Application: 2025/62/93543/W

I write to **OBJECT** to the application proposals.

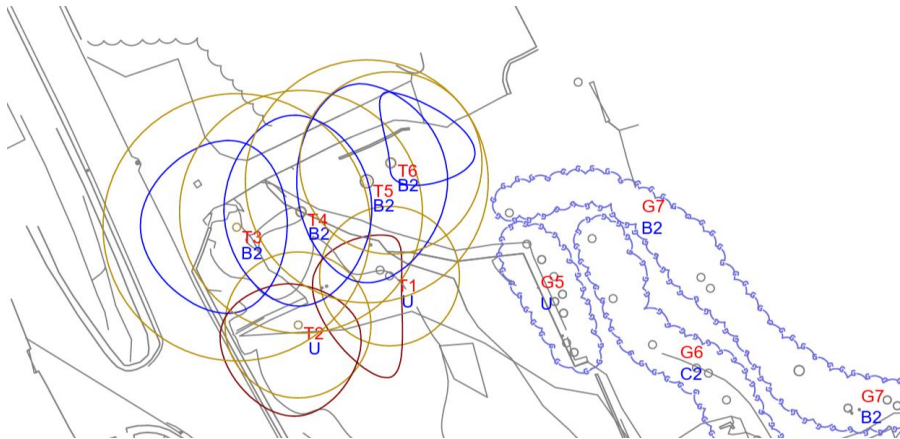
On appraisal of the materials – the site ownership boundary seems incorrect. This will require full verification. The latest site boundary (red ownership boundary) as shown on dwg. 2517-S1-05 Planning Layout is different (varies) to the ownership boundary as showcased on previous site plans submitted by HNA Architects [See App: 2023/90157].

Further, the proposals submitted fail to acknowledge the PRoW that cuts through the application site.

Again, LPA officers shall be required to update all parties on PRoW status. Correct ownership boundary and status on PRoW is required – and in turn, shall allow for accurate design interrogation of the submitted proposals. PRoW connections adjacent too and within the site boundary- should be expressly indicated on all submitted drawings.

A proposed Site Plan should be in circulation with full topography, datums, TPO tree locations [including root and canopy protection zones]. Full details of existing boundary to the east of the site (Green Belt boundary) IS REQUIRED. The reports submitted simply denote such areas as 'inaccessible' and 'subject to confirmation'. This requires verification in advance of submittal- and should form important part of Structural Engineers' proposals.

Tree Plan Extract (including tree numbering):

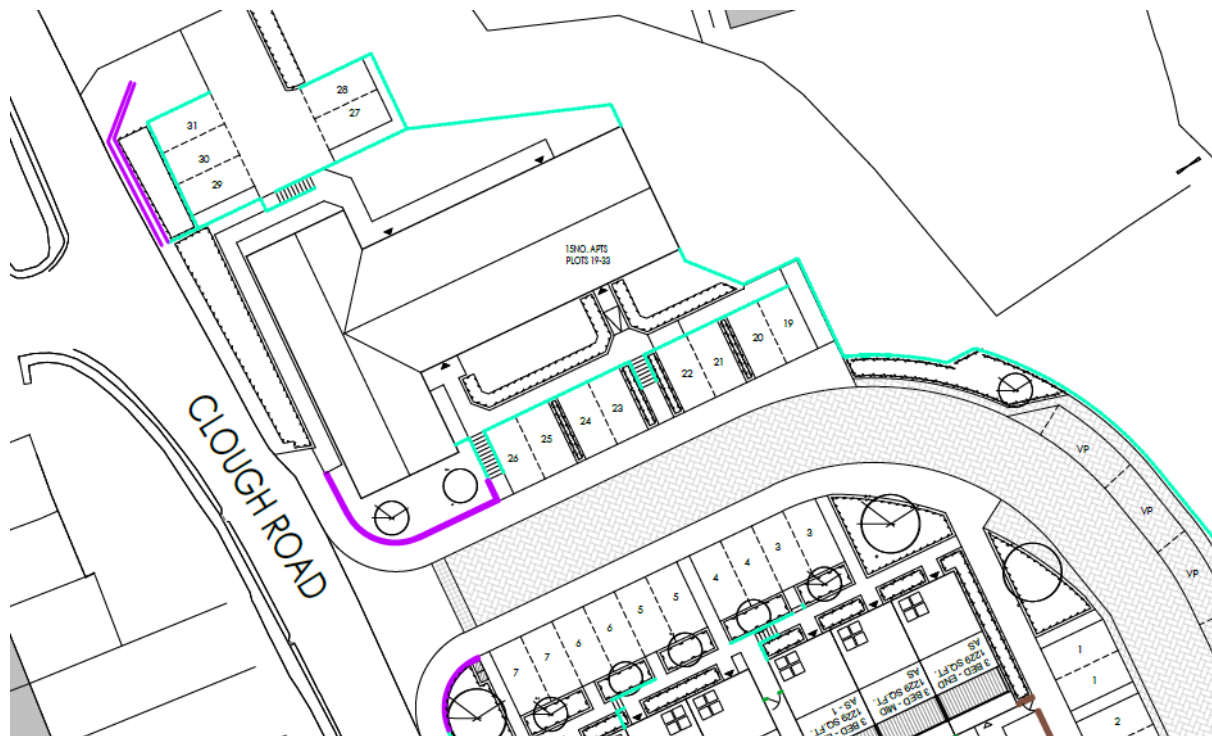
The developer proposes to remove mature trees to the north of the site. I believe the removal of these TPO protected trees should be resisted by the LPA. Aside, the arboriculturist is promoting Trees T1, T2 to be removed as submitted. Without any consultation with required parties.

The arboriculturist report notes Trees T3, T4, T5 and T6 to be retained.

The proposed site plan (extract below) SHOULD have the 'retained' 4no. trees included [T3, T4, T5 & T6] but indicates 3no only. Tree T4 is missing from the proposed site plan:

I believe this is not an oversight. I believe this is intentionally done - to allow for vehicle access to proposed parking bays as showcased on the plans.

The site plan as submitted does not align to the recommendations/ proposals of the arboriculturist report.

The applicant provides a proposed boundary information drawing. Extract below:

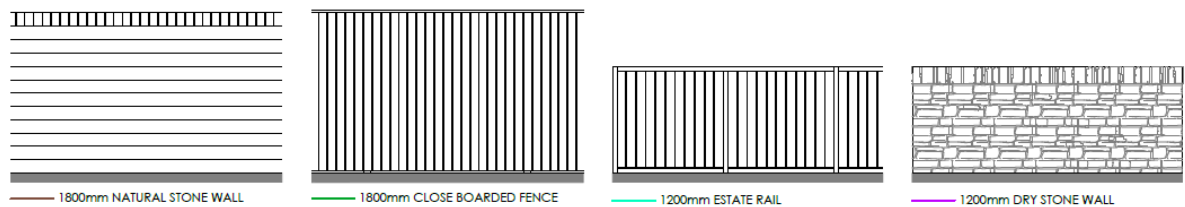
The applicant suggests the boundary walls range from 1200mm – 1800mm. This is wholly incorrect and disingenuous.

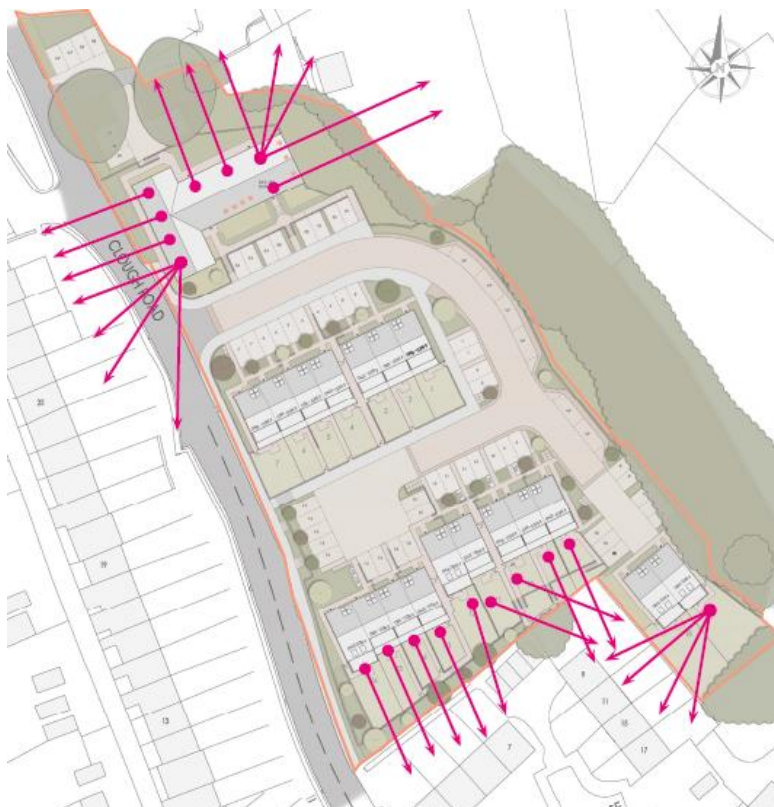
The architect notes “the two-and-a-half-storey dwellings have private terraces that are carefully positioned to make the most of the site’s elevated position and offer long-distance views across Slaithwaite. These elevated outdoor spaces enhance residential amenity while reinforcing the strong relationship between the development and its surrounding landscape”. The architect fails to appreciate the impact of the oddly placed proposed terraces (and overall massing) equates to **substantial overlooking** of neighbouring plots. For ease I markup of the reality of the proposals.

The architect has located terraces to the rear of the homes to the south of the site (all overlooking neighbouring properties garden space and rear facades). The markup drawing also showcases the mass overlooking issues relating to proposed apartment block.
